PIC32MZ Embedded Connectivity with Floating Point Unit (EF) Family Silicon Errata and Data Sheet Clarification

The PIC32MZ Embedded Connectivity with Floating Point Unit (EF) family of devices that you have received conform functionally to the current Device Data Sheet (DS60001320), except for the anomalies described in this document.

The following typographic corrections and clarifications are to be noted for the latest version of the device data sheet (DS60001320H):

FIGURE 1: Posc CRYSTAL CIRCUIT

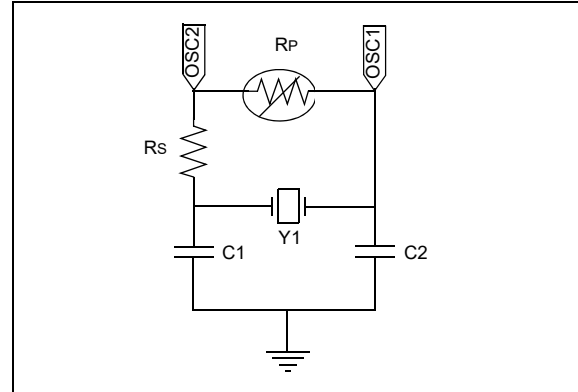
Revision A1 Silicon: A crystal oscillator cannot be used as an input to the Primary Oscillator (Posc) pins OSC1 and OSC2.

Revision A3 and B3 Silicon: The Posc has been tested in a normal power-up sequence and supports specific crystal operation.

The Primary Oscillator (Posc) has been characterized to operate at 8 MHz, 12 MHz, and 24 MHz when the circuit in [Figure 1](#) is implemented, and the operating conditions listed in [Table 3](#) are met.

Crystal Frequency (see Note 1)	Series Resistor (Rs)	Posc Gain Setting POSCGAIN<1:0> (DEVCFG0<20:19>)	Posc Boost Setting POSCBOOST (DEVCFG0<21>)
8 MHz	2 kΩ	'0b00 (GAIN_0)	'0b1 (ON)
12 MHz	1 kΩ	'0b00 (GAIN_0)	'0b1 (ON)
24 MHz	0 kΩ	'0b00 (GAIN_0)	'0b1 (ON)

- Note 1:** Using any other crystal frequency will require special component selection and characterization.
2: A parallel resistor (Rp) should not be used to increase the gain of the POSC.

64-PIN QFN⁽⁴⁾ AND TQFP (TOP VIEW)

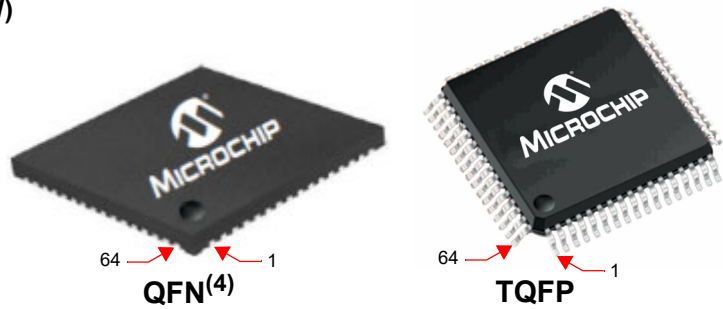
In Table 2. “Pin Names for 64-pin QFN and TQFP Devices” of the current data sheet, the AECRS_{DV} signal was erroneously omitted from the pin number 44 and added to the pin number 62. The correct assignment is shown in bold type in the following table.

Pin #	Full Pin Name	Pin #	Full Pin Name
29	AN9/RPB14/SCK3/PMA1/RB14	61	TRD1/SQID1/ERXD0/PMD1/RE1
30	AN10/EMDC/AEMDC/RPB15/OCFB/PMA0/RB15	62	TRD2/SQID2/ERXDV/ECRSDV/PMD2/RE2
31	OSC1/CLKI/RC12	63	TRD3/SQID3/ERXCLK/EREFCLK/RPE3/PMD3/RE3
32	OSC2/CLKO/RC15	64	AN18/ERXERR/PMD4/RE4
